MILITARY SPECIFICATION

PROJECTILE, 8 INCH, HE, RA, M650
AFT WARHEAD SECTION AND STRIPPABLE COATING ASSEMBLY

This amendment forms a part of Military Specification MIL-P-48322B (AR), dated 22 May 1981 and is approved for use by the US Army Armament, Munitions and Chemical Command, and is available for use by all Departments and Agencies of the Department of Defense.

FIGURE 2
Depth of Knurl

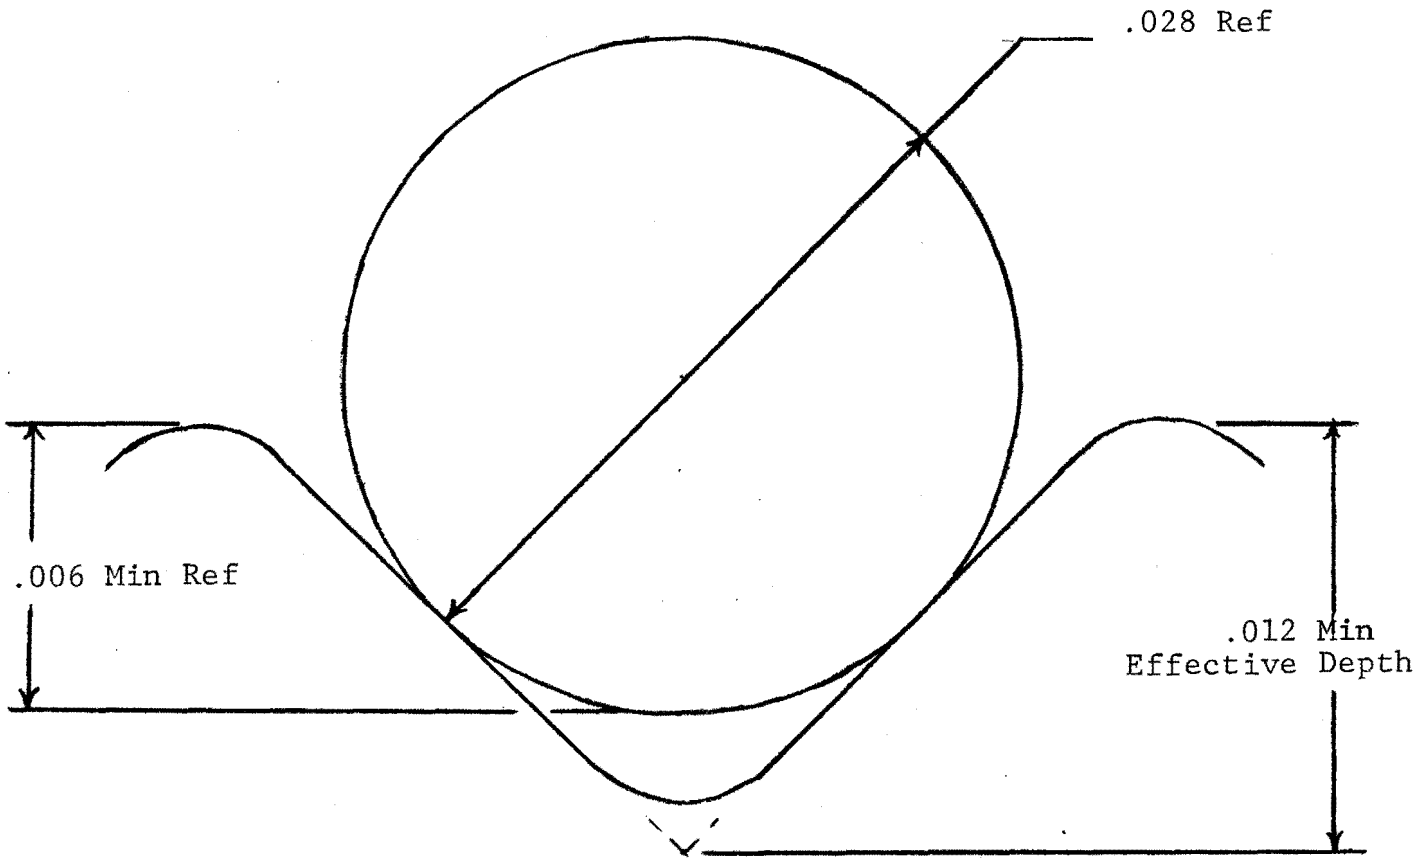
Add the following new paragraph:

"3.15 Knurl. The minimum effective depth of the radial grooves in the knurl shall be .012 inches between the first and sixth peaks (See Figure 2)."

Add "Figure 2" as follows:

"4.4.3.11 Depth of knurl

4.4.3.11.1 Initial sampling. The first pieces from each tool, forming the radial groove, shall be inspected for depth until one part has been accepted.

4.4.3.11.2 Subsequent sampling. If the life of the tool forming the radial grooves is 50 parts or less, the last part formed by each tool shall be inspected. If tool life is greater than 50 parts, an additional inspection of one part from each 50 shall be performed. If the knurl depth is less than .012 inches, production represented by that sample shall be rejected, production shall be stopped and corrective action taken. Sampling for any tool producing a rejected part shall revert to 4.4.3.11.1 if that tool is returned to production."

"4.5.14 Depth of knurl. The depth of the radial groove in the knurl shall be checked using a dial indicating depth gage or approved equivalent."

FIGURE 3
Approximate Location of Tension and Charpy Base Specimens
(T- Tensile, C - Charpy)

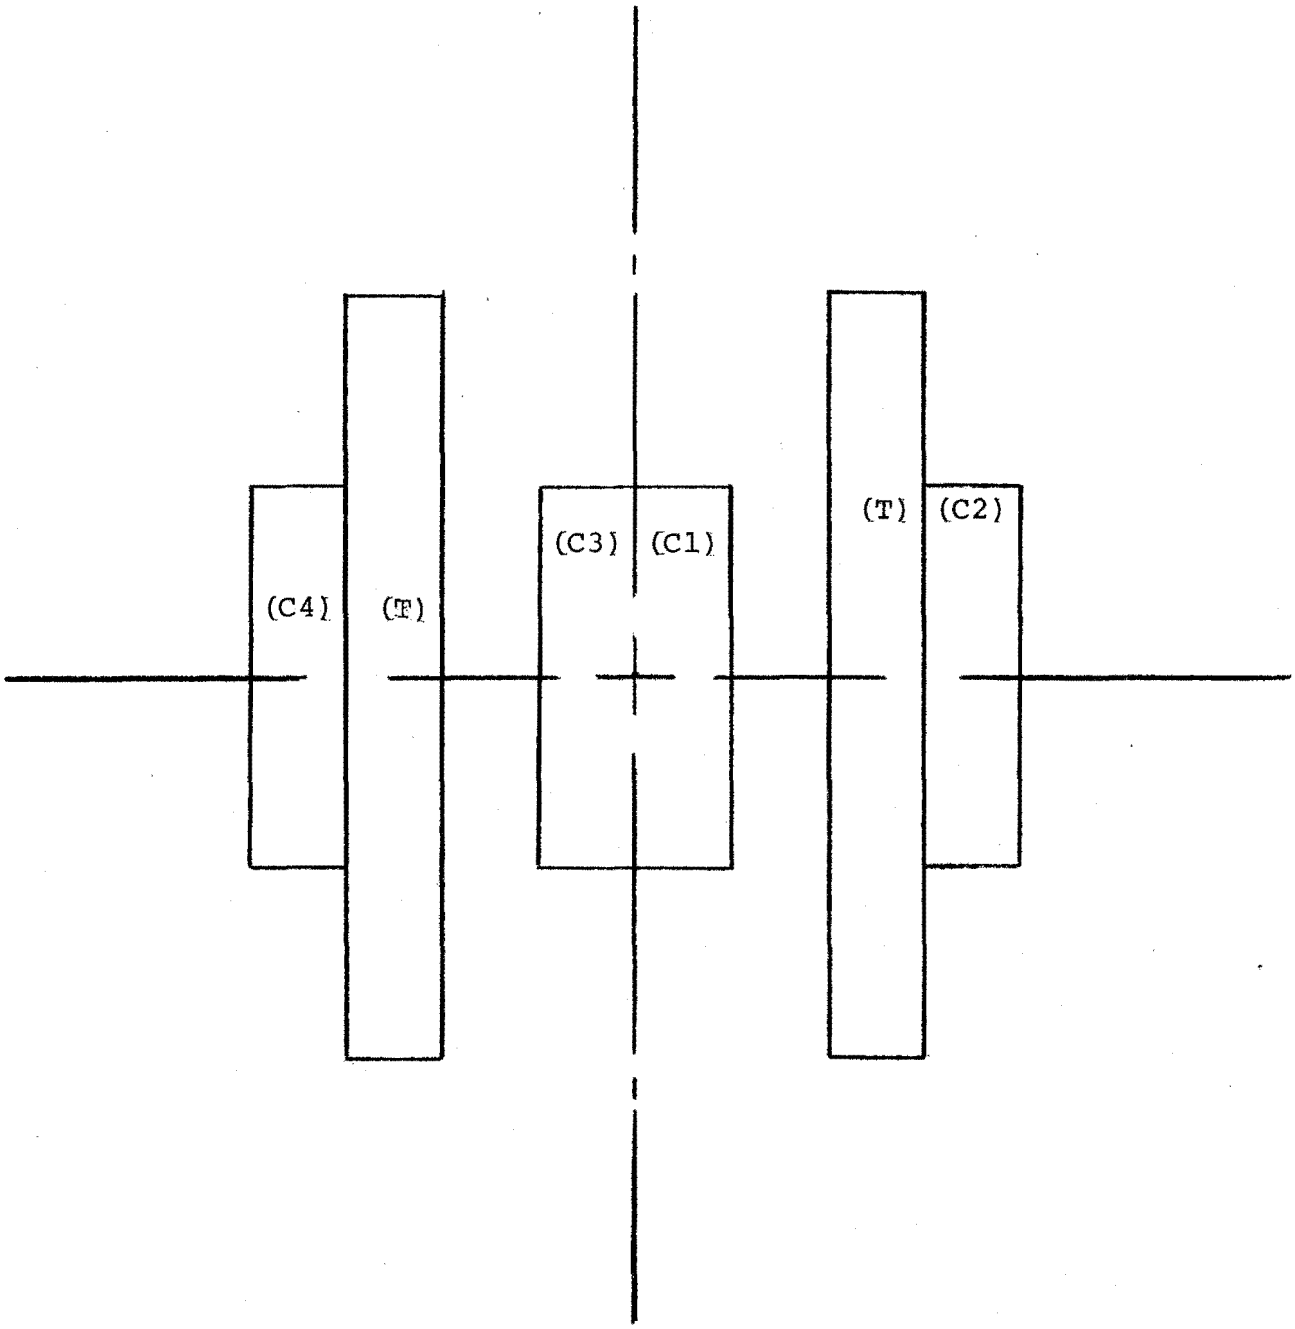
4.5.3: Delete in its entirety and substitute the following:

4.5.3 Slow bend precrack charpy. The two specimens shall be taken from locations C1 and C2 on Figure 3. The test shall be conducted at a specimen temperature of -65 degree fahrenheit (^{O}F). The test shall be conducted in accordance with the procedure defined in the Appendix of this specification with the notches machined across the rear face of the specimen. Locations C3 and C4 on Figure 3 shall be used for replacement specimens for locations C1 and C2 respectively."

Add "Figure 3" as follows:
